SERVICE MANUAL

COLOUR TELEVISION

AV-32WFP1EU_(A) AV-32WFP1EUI_(A) AV-32WFP1EK_(A)

Supplementary

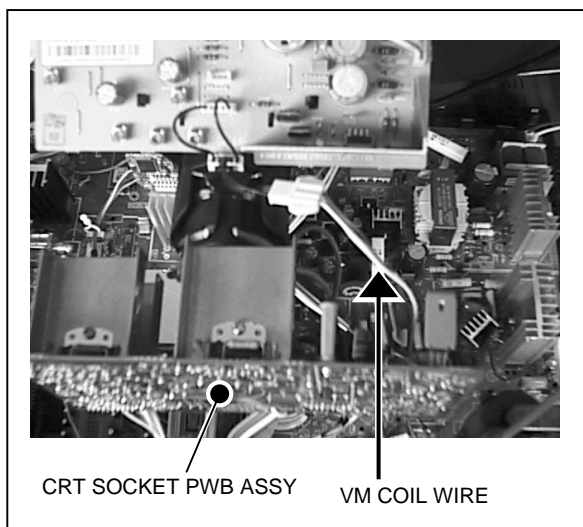
To improve CRT performance, CRT manufacturer has changed location of VM coil wire connector on the CRT neck.

When changing CRT from old to new type, it is necessary to add extension cable CHHB03-100R-SA, between CRT SKT PCB and new VM coil connector.

When ordering replacement CRT, Please order CHHB03-100R-SA at same time.

[Fig.1]

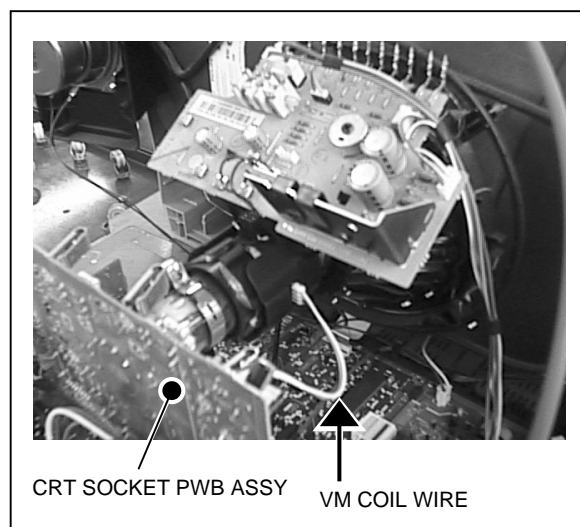
Old type: Has a short VM wire, coming from the CRT VM PCB/Coil Assy for connecting to CRT PCB VM coil wire.

New type: VM coil wire is connected directly into the right hand side of CRT neck.

[Fig.3]

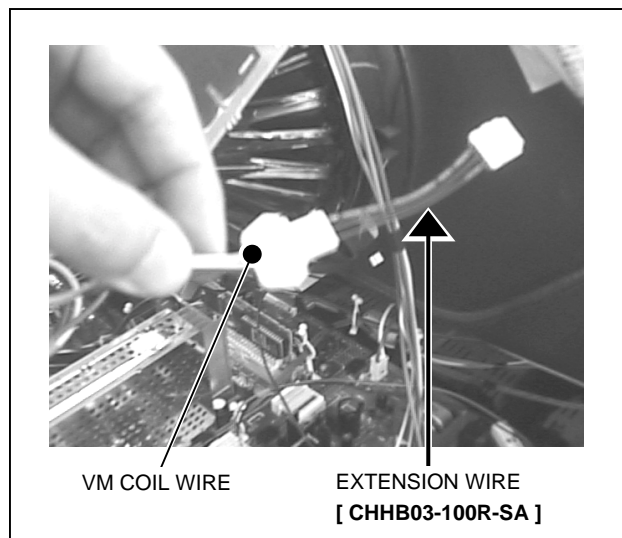
- ① Order CHHB03-100R-SA, at the same time as CRT.
- ② Attach one end of CHHB03-100R-SA, to VM coil Wire. (See Fig 3)
- ③ Insert opposite end of CHHB03-100R-SA wire, into CRT's VM coil wire connection. (See Fig 2)
